## Exhibit K - Design Review Approval

STAFF LEVEL PROJECT REVIEW

DR Number: DR07-0266  
Address: 3940 14<sup>th</sup> Street  
APN: 020-0073-028  
Description: Small Subdivision

Exhibit C – Plan A Floor Plan

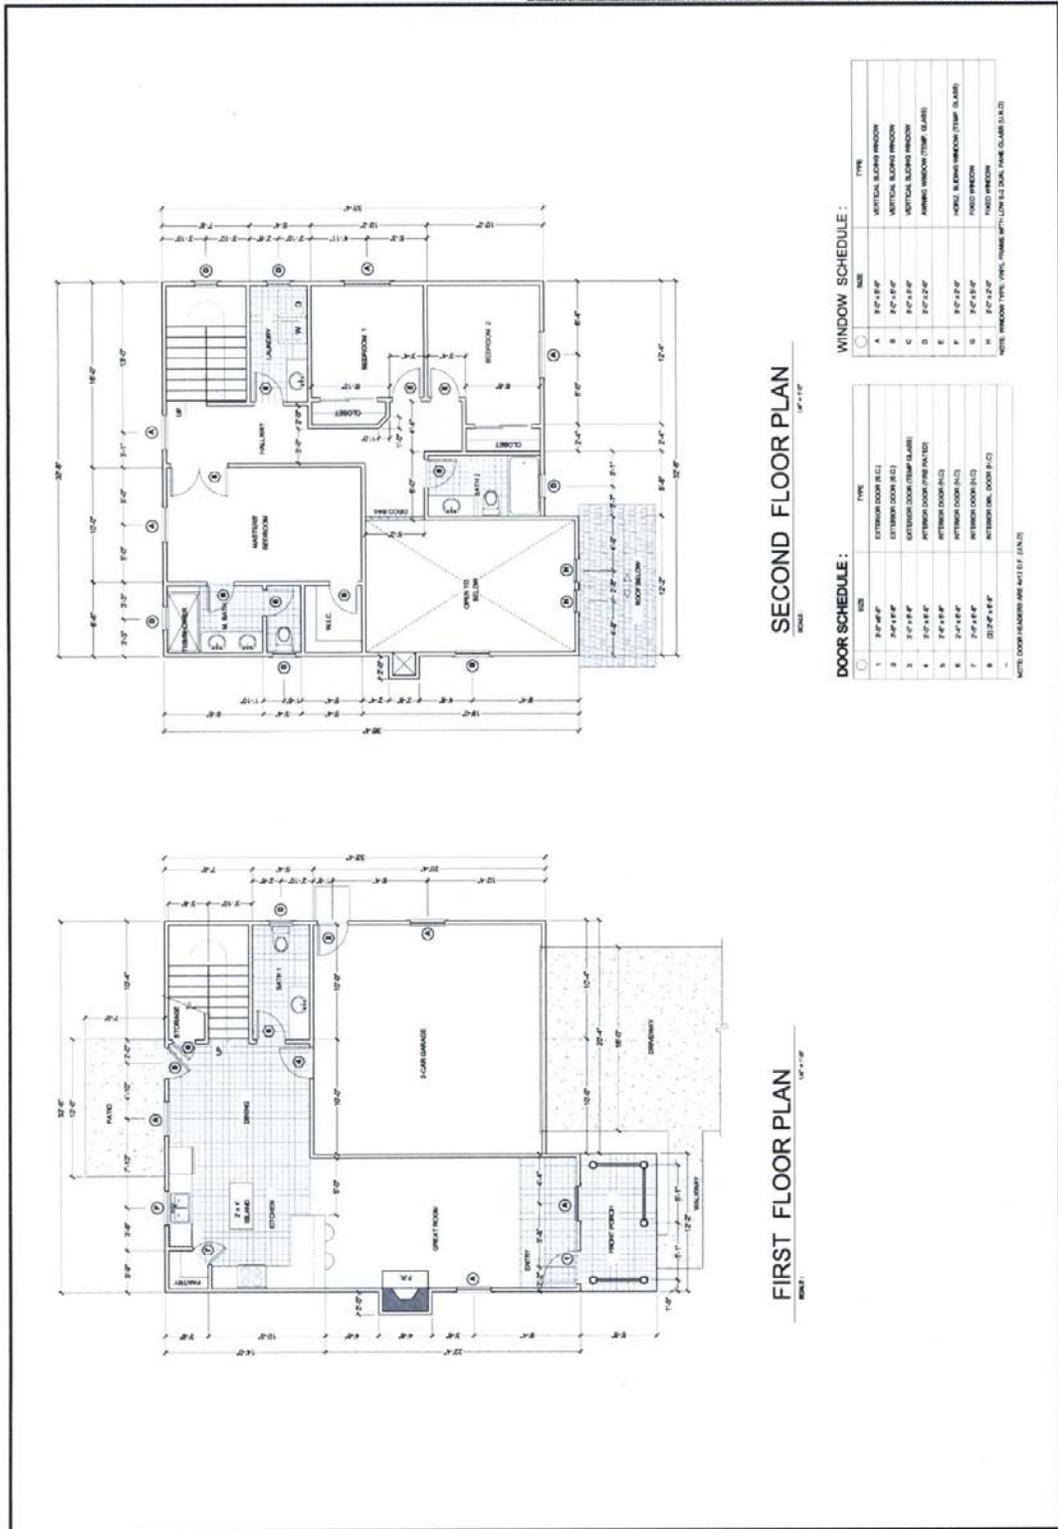
**Conditions for Floorplan A, Lot 6:**

1. New roof pitch (5 in 12) shall be provided per approved plans. A minimum 30-year laminated dimensional composition shingle shall be provided per approved plans.

2. New 6-inch exposure wood or fiber cement horizontal lap siding shall be provided on all elevations per approved plans. All lap siding shall be smooth finish, no stamped grain.

3. Gable roof at front elevation shall be provided per approved plans. New board and batten (wood or fiber cement) vertical siding at front elevation gables shall be provided per approved plans.

4. Horizontal 18" wood trim board shall be provided on all elevations per approved plans.
5. Wide frame vinyl windows with decorative wood (1" X 4") trim, projecting wood sills and aprons shall be provided per approved plans. Grids shall be provided on all elevation windows per approved plans.

6. Window shutters shall be provided at front elevation windows per approved plans.
7. Front porch shall be provided per approved plans. New decorative wood front porch columns with 18" built-out wood bases shall be provided per approved plans. New top mounded wood guardrail and bottom rail with 2" X 2" wood pickets at 4" centers, shall be provided at front porch per approved plans.

8. New chimney with 6-inch exposure wood or fiber cement horizontal lap siding shall be provided per approved plans.
9. Gable vents with wood louvers and 1" X 2" decorative trim shall be provided per approved plans.

10. Front entry door with raised panel design shall be provided per approved plans.
11. Raised panel garage door with top window row shall be provided per approved plans.

12. Provide painted gutters and downspouts per redlined drawings.
13. Provide decorative light fixtures at front and rear doors, and garage door per approved plans.

Exhibit F – Plan B Elevation

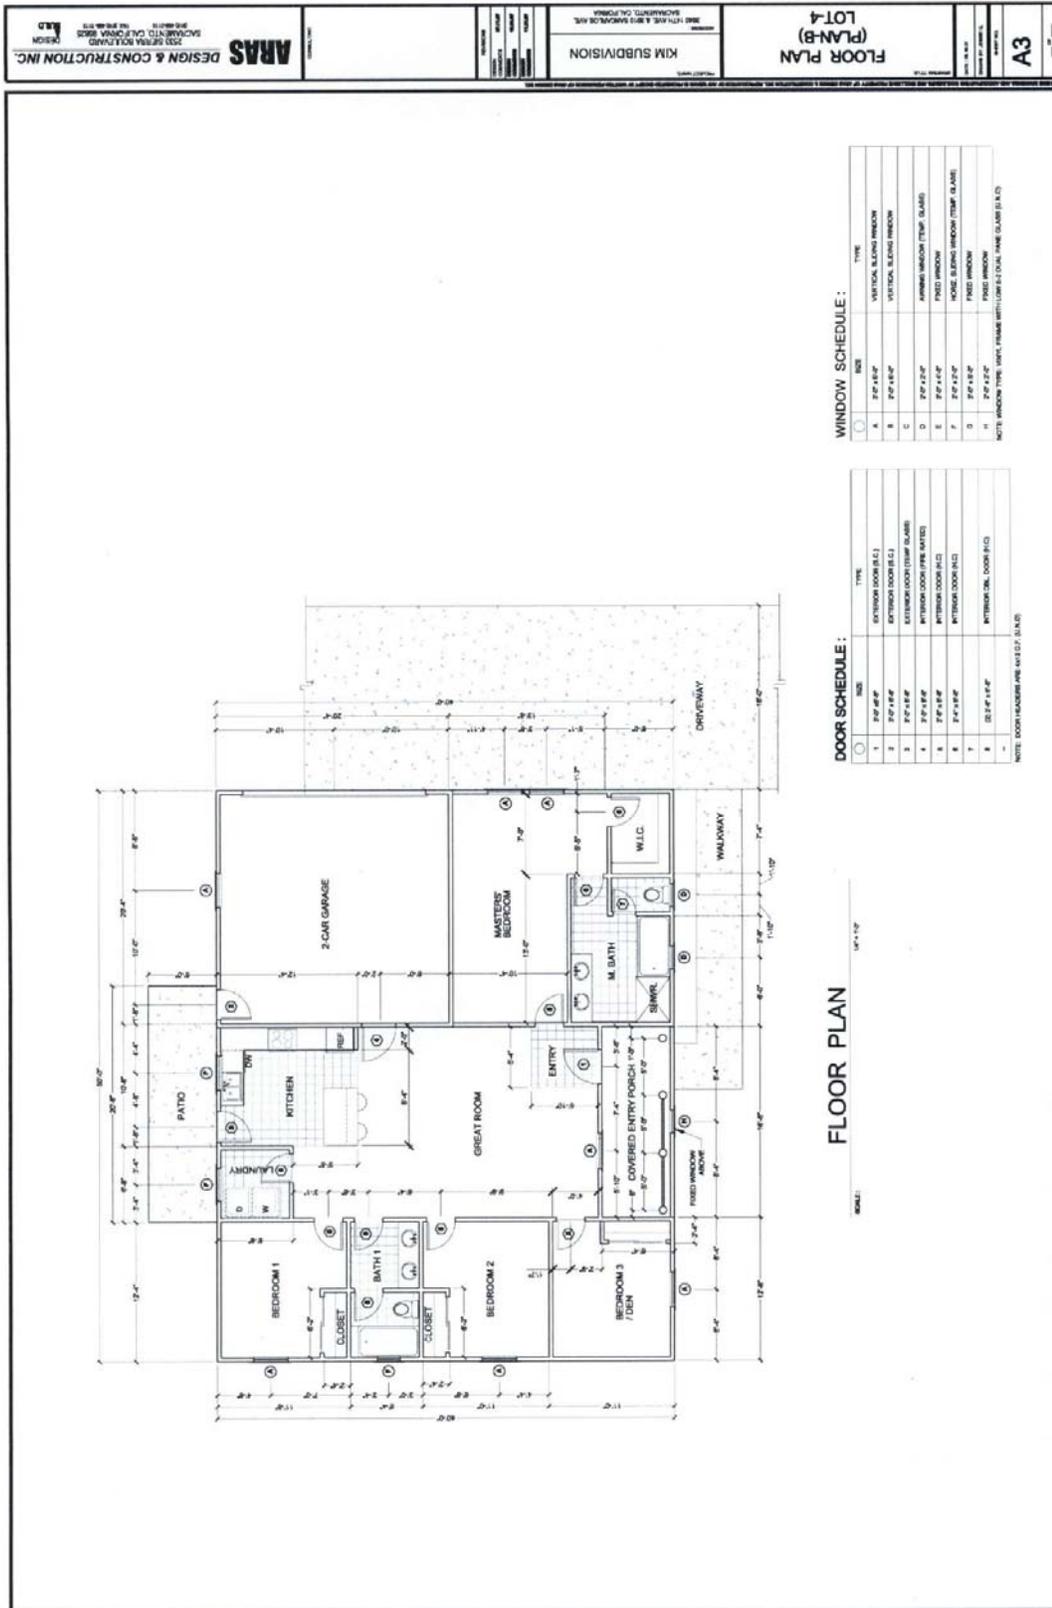
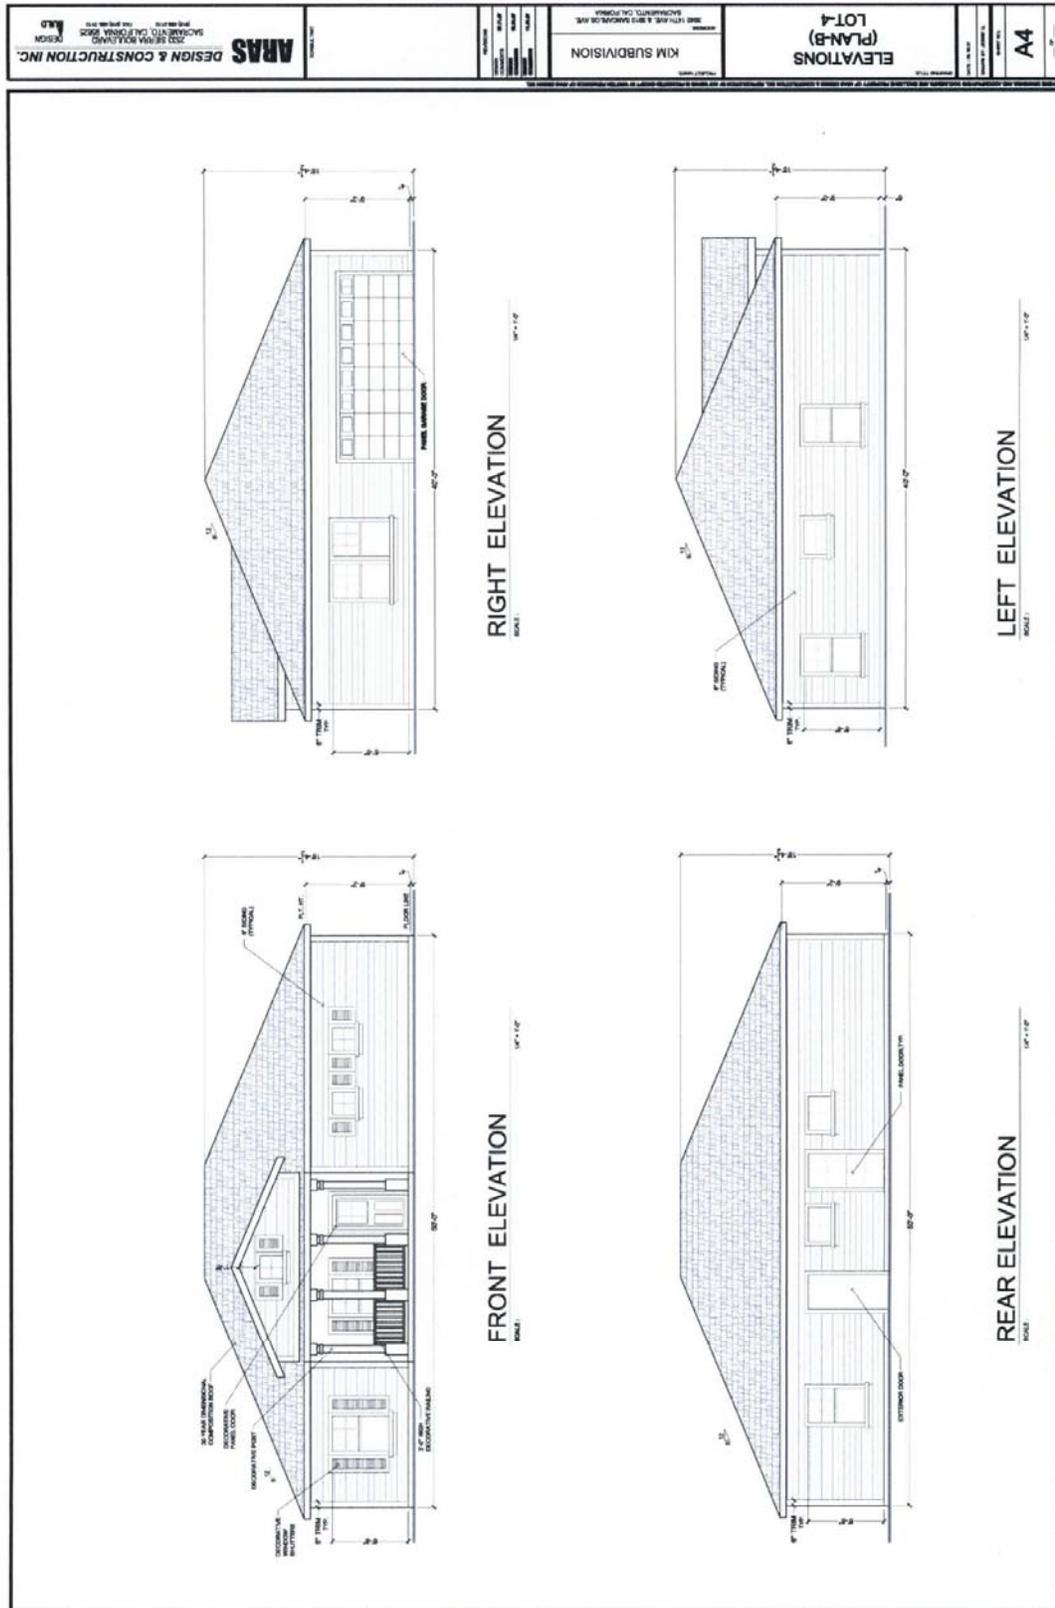
**Conditions for Floorplan B, Lot 4:**

14. New roof pitch (5 in 12) shall be provided per approved plans. A minimum 30-year laminated dimensional composition shingle shall be provided per approved plans.

15. New 6-inch exposure wood or fiber cement horizontal lap siding shall be provided on all elevations per approved plans. All lap siding shall be smooth finish, no stamped grain.

16. Wide frame vinyl windows with decorative wood (1" X 4") trim, projecting wood sills and aprons shall be provided per approved plans. Grids shall be provided on all elevation windows per approved plans.

17. Window shutters shall be provided at front elevation windows per approved plans.
18. Front porch shall be provided per approved plans. New decorative wood front porch columns with 18" built-out wood bases shall be provided per approved plans. New top mounded wood guardrail and bottom rail with 2" X 2" wood pickets at 4" centers, shall be provided at front porch per approved plans.

19. Front entry door with raised panel design shall be provided per approved plans.
20. Raised panel garage door with top window row shall be provided per approved plans.

21. Provide painted gutters and downspouts per redlined drawings.
22. Provide decorative light fixtures at front and rear doors and garage door per approved plans.

Exhibit G – Plan C Floor Plan

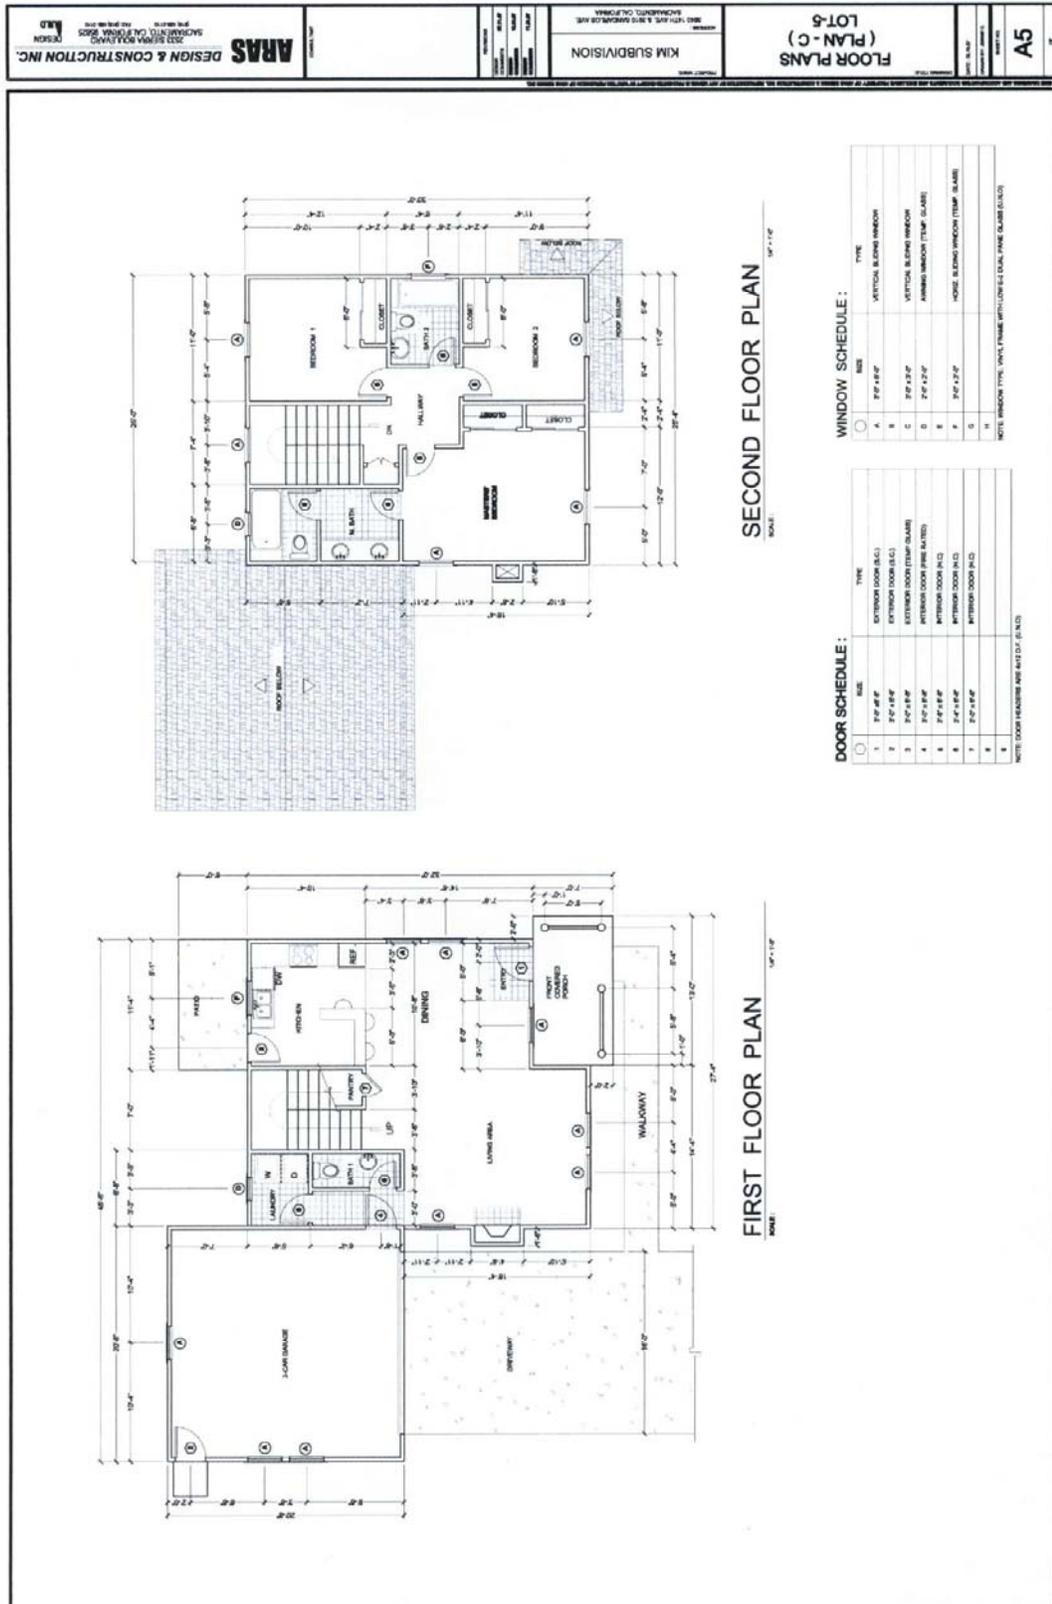
**Conditions for Floorplan C, Lot 5:**

23. New roof pitch (5 in 12) shall be provided per approved plans. A minimum 30-year laminated dimensional composition shingle shall be provided per approved plans.

24. New 6-inch exposure wood or fiber cement horizontal lap siding shall be provided on all elevations per approved plans. All lap siding shall be smooth finish, no stamped grain.

25. New board and batten (wood or fiber cement) vertical siding at front and rear elevation gables shall be provided per approved plans.
26. Horizontal 18" trim board shall be provided on all elevations per approved plans.

27. Wide frame vinyl windows with decorative wood (1" X 4") trim, projecting wood sills and aprons shall be provided per approved plans. Grids shall be provided on all elevation windows per approved plans.

28. Window shutters shall be provided at front elevation windows per approved plans.
29. Front porch shall be provided per approved plans. New decorative wood front porch columns with 18" built-out wood bases shall be provided per approved plans. New top mounded wood guardrail and bottom rail with 2" X 2" wood pickets at 4" centers, shall be provided at front porch per approved plans.

30. New chimney with 6-inch exposure wood or fiber cement horizontal lap siding shall be provided per approved plans.
31. Gable vents with wood louvers and 1" X 2" decorative trim shall be provided per approved plans.

32. Front entry door with raised panel design shall be provided per approved plans.
33. Raised panel garage door with top window row shall be provided per approved plans.

34. Provide painted gutters and downspouts per redlined drawings.
35. Provide decorative light fixtures at front, rear door, garage man-door and garage door per approved plans.

Exhibit I – Plan E Floor Plan

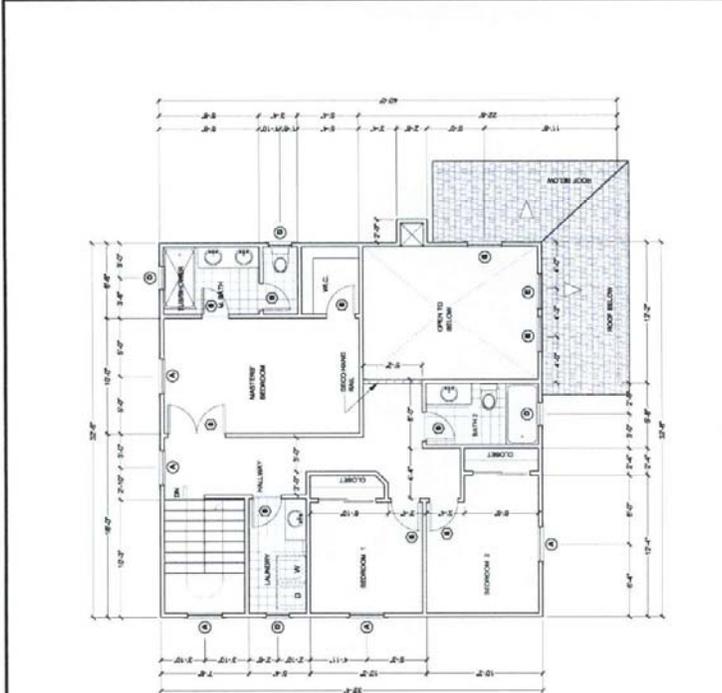
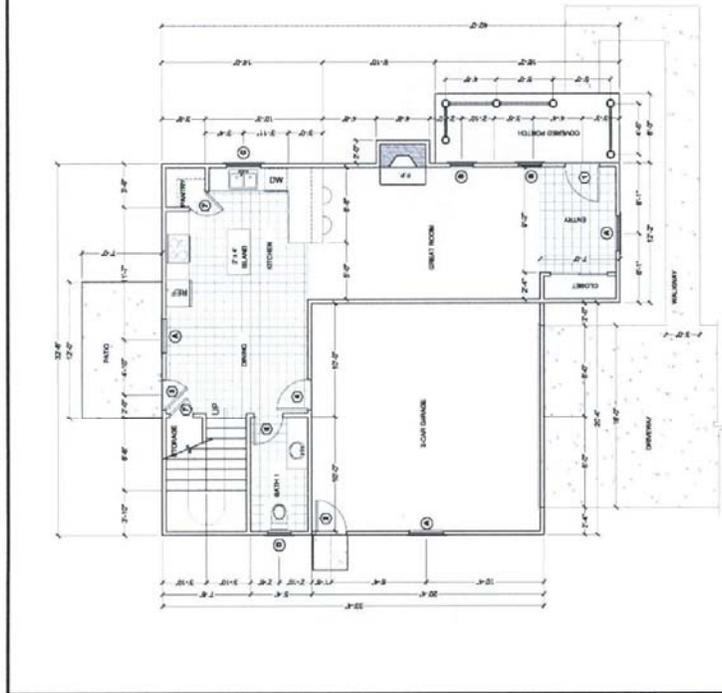
**Conditions for Floorplan E, Lot 2:**

36. New roof pitch (5 in 12) shall be provided per approved plans. A minimum 30-year laminated dimensional composition shingle shall be provided per approved plans.

37. New 6-inch exposure wood or fiber cement horizontal lap siding shall be provided on all elevations per approved plans. All lap siding shall be smooth finish, no stamped grain.

38. Horizontal 18" wood trim board shall be provided on all elevations per approved plans.
39. Wide frame vinyl windows with decorative wood (1" X 4") trim, projecting wood sills and aprons shall be provided per approved plans. Grids shall be provided on all elevation windows per approved plans.

40. Window shutters shall be provided at front and left elevation windows per approved plans.
41. Front porch shall be provided per approved plans. New flared out decorative wood columns with 36" built-out wood bases shall be provided per approved plans. New top mounded wood guardrail and bottom rail with 2" X 2" wood pickets at 4" centers, shall be provided at front porch per approved plans.

42. New chimney with 6-inch exposure wood or fiber cement horizontal lap siding shall be provided per approved plans.
43. Front entry door with raised panel design shall be provided per approved plans.

44. Raised panel garage door with top window row shall be provided per approved plans.
45. Provide painted gutters and downspouts per redlined drawings.

46. Provide decorative light fixtures at front, rear and side doors, and garage door per approved plans.
